# Access Compliance Report

## Public Rights-of-Way

### (Curb Ramps)

Intersection ID: 21085	Main Street: LARKFIELD_LN	Cross Street: WOODSTREAM_DR	Location: SW
ADA ID: 9AD3D8F22524	Ramp Type: BlendTrans1	Initial Pass/Fail: Fail	Overall Compliance: No
		Severity Score: 8.75

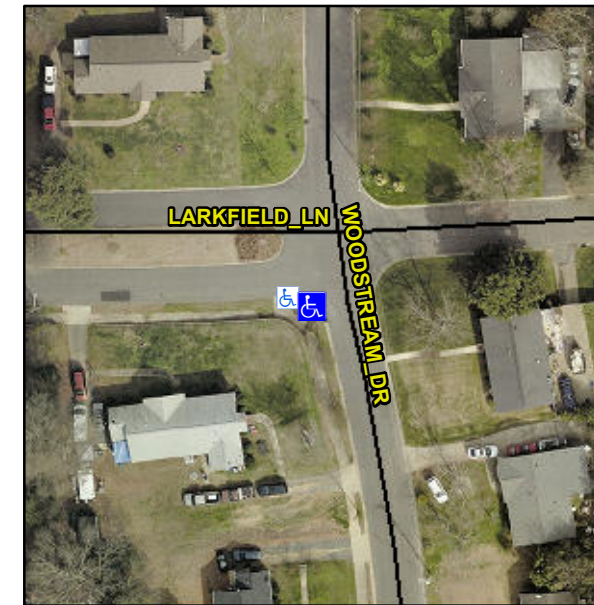
**Not Found, R304.5.1**

Compliance	Description	Data	Compliance	Description	Data
N/A	Ramp Length (in)	94.0	Yes	BlendTrans Slope (%)	4.7
No	Ramp Width (in)	43.0	Yes	BlendTrans XSlope (%)	1.6
N/A	Flare Type LT	N/A	N/A	Flare Type RT	N/A
N/A	Flare Slope LT (%)	N/A	N/A	Flare Slope RT (%)	N/A
N/A	Flare Traversable LT?	N/A	N/A	Flare Traversable RT?	N/A
N/A	Landing Length (in)	N/A	N/A	DWS Provided?	N/A
N/A	Landing Width (in)	N/A	N/A	DWS Contrast?	N/A
N/A	Landing Slope (%)	N/A	N/A	DWS Length (in)	N/A
N/A	Landing X Slope (%)	N/A	N/A	DWS Full Width?	N/A
N/A	Landing Curb? (Y/N)	N/A	N/A	DWS Offset (in)	N/A
N/A	Shared Landing?	N/A			
N/A	Gutter Ponding?	N/A	N/A	Gutter Slope (%)	N/A
N/A	Gutter Lip Ht (in)	N/A	N/A	Gutter X Slope (%)	N/A
N/A	Painted X Walk1?	No	N/A	Painted X Walk2?	N/A
	X Walk 1 Direction	To E		X Walk 2 Direction	N/A
	X Walk 1 Width (in)	N/A		X Walk 2 Width (in)	N/A
	X Walk 1 Slope (%)	3.7		X Walk 2 Slope (%)	N/A
	X Walk 1 X Slope (%)	0.8		X Walk 2 X Slope (%)	N/A

N/A	Ramp inside XWalk1?	N/A	N/A	Ramp inside XWalk2?	N/A
	Road Slope (%)	0.8		Clear Space?	N/A
	Road X Slope (%)	3.7	N/A	Clear Space to XWalk (in)	N/A
N/A	Any Obstructions?	N/A	N/A	Storm Grate/Utility Hazard?	N/A
	Obstruction Type			Storm Grate/Utility Type	
		N/A			N/A
			Yes	Surface Condition? (G/P)	Good
			No	Curb Slope (%)	7.7

**Remove & Replace Curb Ramp With Two New Directional Ramps or Equivalent.**
